ATTACHMENT A

AEP:NRC:00297

### CHANGE NO. 1

#### Revision to Table 2.2-1 "Reactor Trip System Instrumentation and Trip Setpoints" and Table 3.2-1 "DNB Parameters" - Unit No. 2

FIGURE 3.2-2  $K(Z)$  - NORMALIZED  $F_Q(Z)$  AS A FUNCTION OF CORE HEIGHT

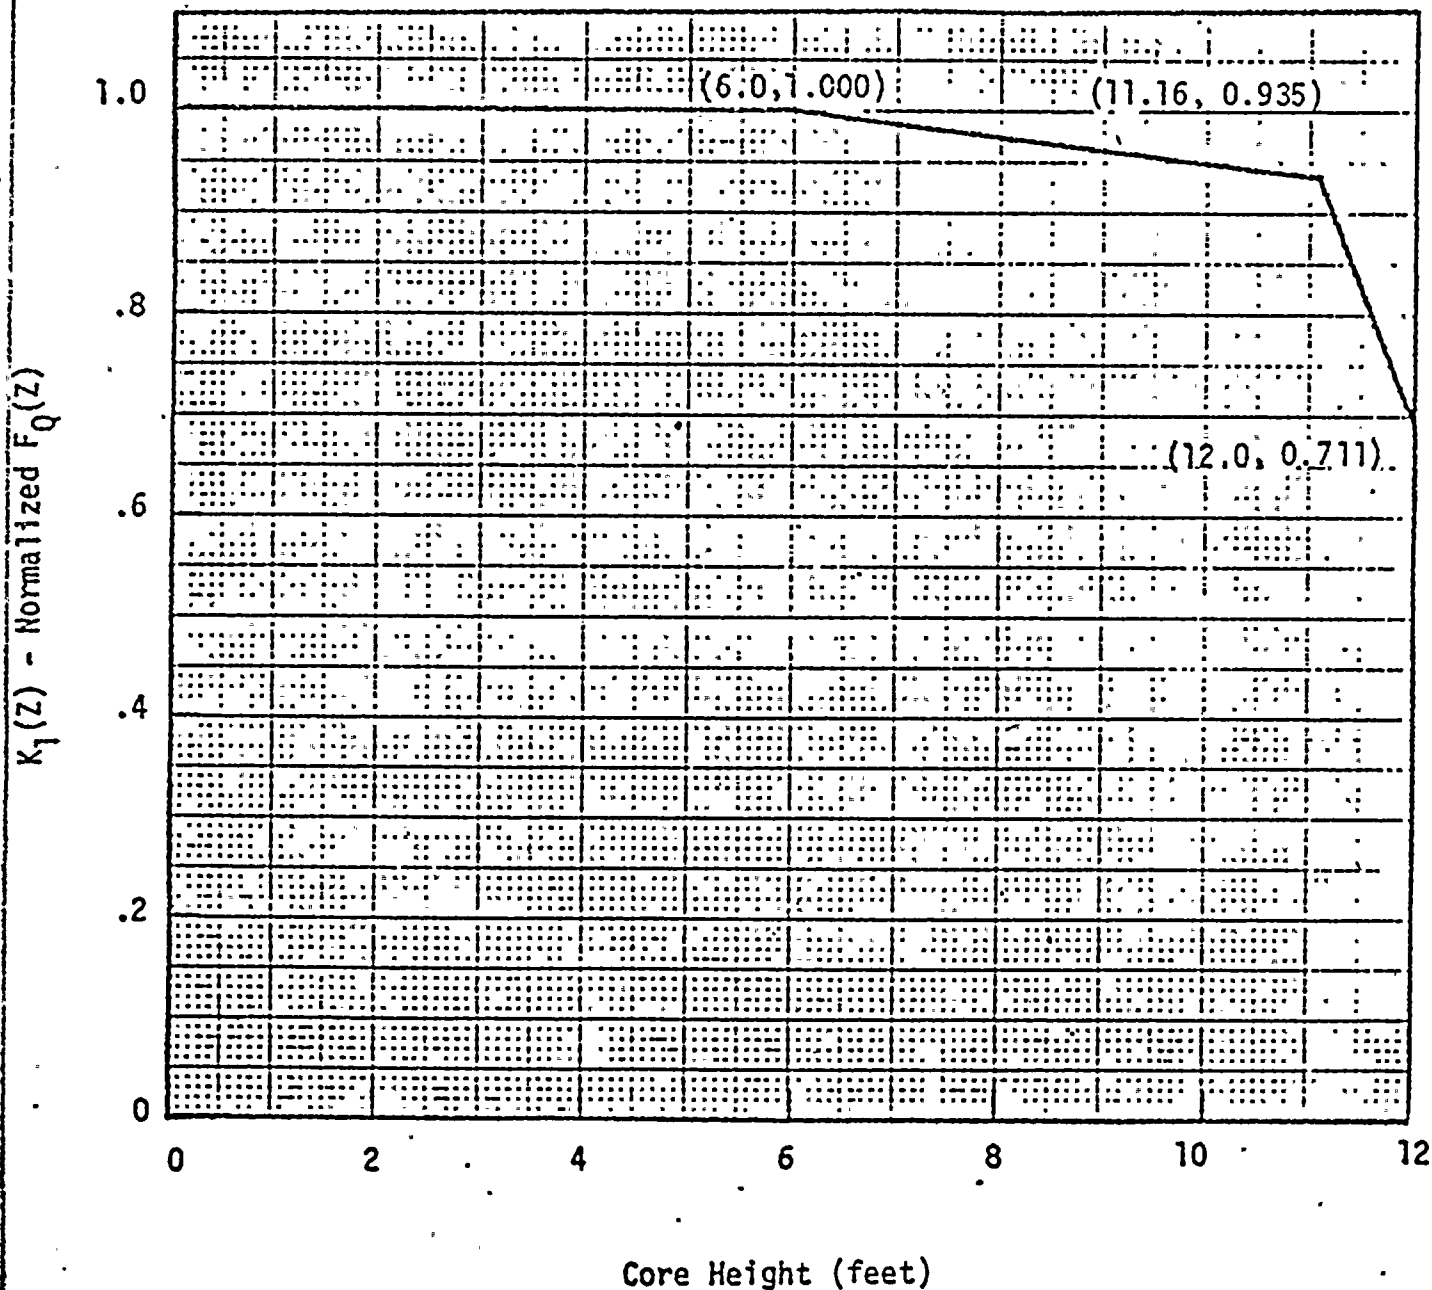
#### Revision to Item 3.2.2, Figure 3.2-2 and Basis Item 3/4 2.1 - Unit No. 2

This change involved lowering the maximum allowable  $F_Q(Z)$  limits. The maximum value is being reduced from 2.32 to 2.11. At present, the 2.11 limit is being used on an administrative basis in compliance with the NRC order which followed the discovery of a 'logic inconsistency' in the metal-water reaction calculation of the Westinghouse ECCS Evaluation Models. The reason for this revision is to change the status of the limit from an administrative limit to a Technical Specification limit. The present administrative limits were established after a new Westinghouse ECCS analysis was performed in which the logic inconsistency was corrected. These results were transmitted to you on April 28, 1978. This change will not affect the health and safety of the public.

$$F_Q(Z) \leq \frac{[2.11]}{P} [K(Z)] \text{ for } P > 0.5$$

Basis:  $F_Q(Z) \times P$  ECCS limit of 2.11

FIGURE 3.2-1 AXIAL FLUX DIFFERENCE LIMITS AS A FUNCTION OF RATED THERMAL POWER

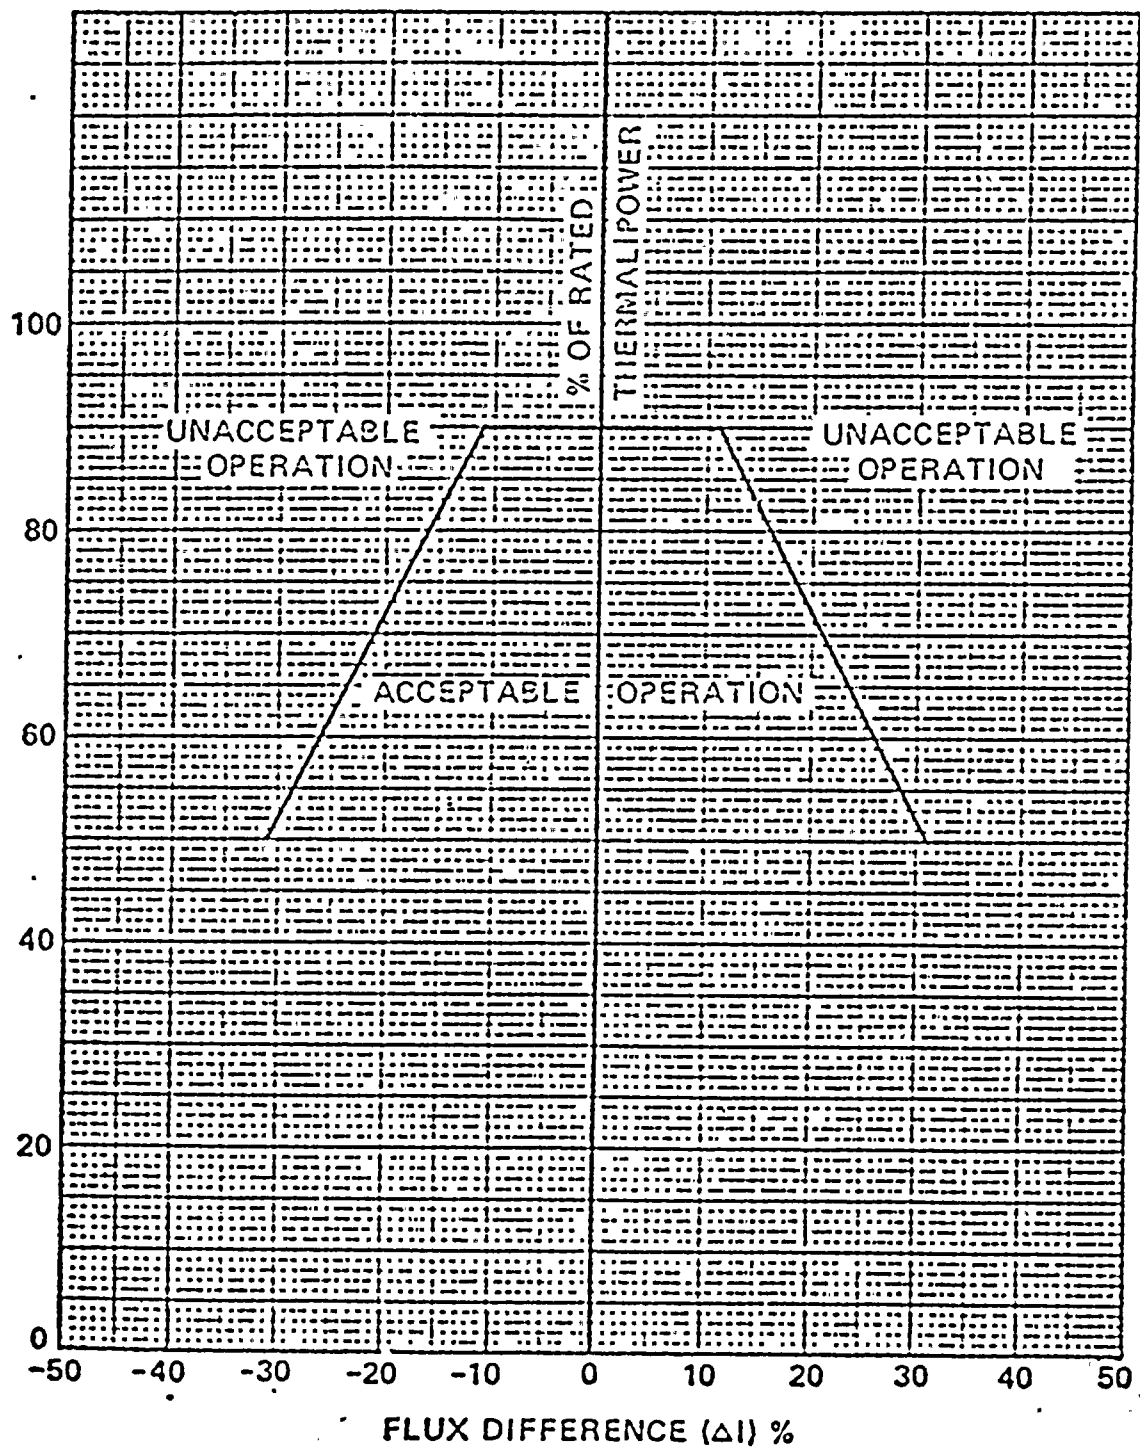
##### Revision to Item 3.2.1 and Figure 3.2-1 - Unit No. 2

This change involves increasing the upper power limit for the taking of action from 84% to 90% Rated Thermal Power. The technical basis for this change is the same as that of Change No. 3. This change will not adversely affect the health and safety of the public.

- a) With the indicated AXIAL FLUX DIFFERENCE outside of the  $\pm 5\%$  target band about the target flux difference and with THERMAL POWER:
  - 1. Above 90% of RATED THERMAL POWER, within 15 minutes:

- a) Either restore the indicated AFD to within the target band limits, or
    - b) Reduce THERMAL POWER to less than 90% of RATED THERMAL POWER.
  - 2. Between 50% and 90% of RATED THERMAL POWER:
